CITY OF ALBUQUERQUE

**Re: Shopping Center
1220 Eubank Blvd. NE
Request 30-Temporary C.O. - Accepted
Engineer's Stamp dated: 3-11-16 (J21D045)
Certification dated: 1-26-17**

GRADING AND DRAINAGE PLAN

A PROPOSED
GRADING AND DRAINAGE PLAN
FOR A COMMERCIAL STRIP CENTER
1220 EUBANK BLVD. N.E.
ALBUQUERQUE, NEW MEXICO
JANUARY, 2016

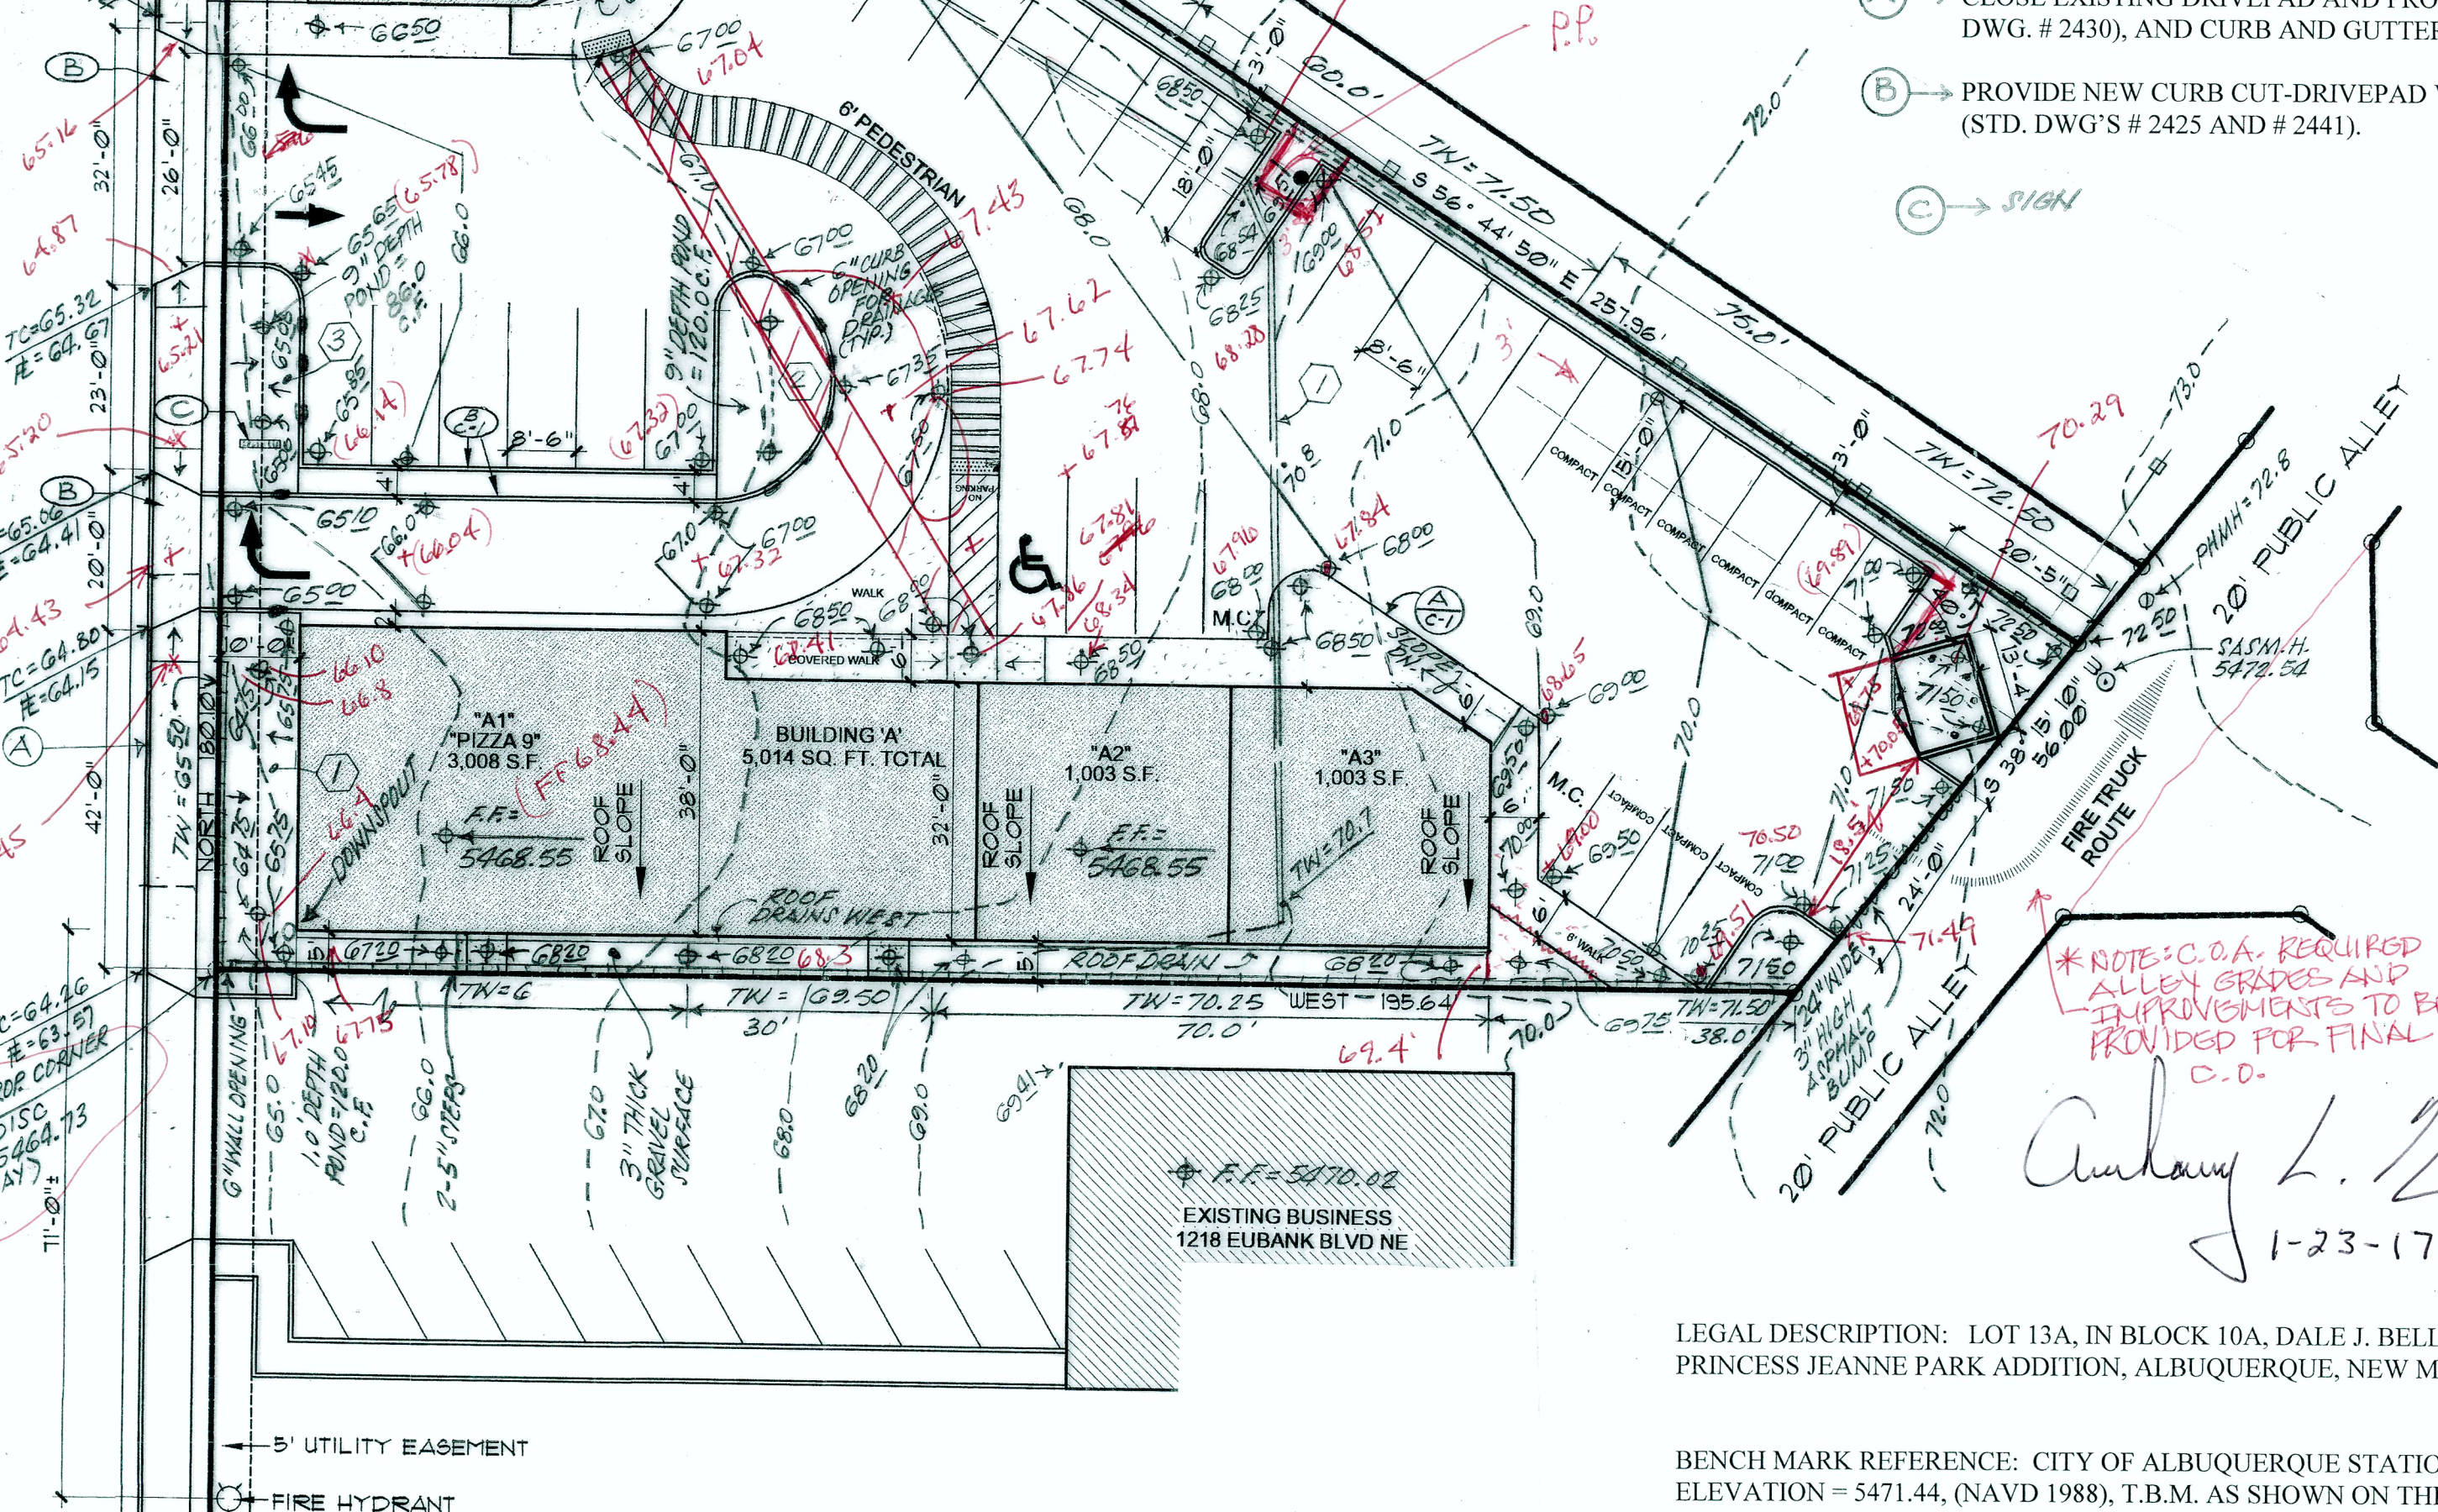
- Alley grades and improvements to be provided. Submit plans thru DRC for approval.
- Pond #1 grades need to be corrected.
- Remove notes referring to pond #2.
- Remove note #1 referring to existing retaining wall.
- Correct drainage on north side against building B.

An inspection by our office will need to take place after these corrections are made.
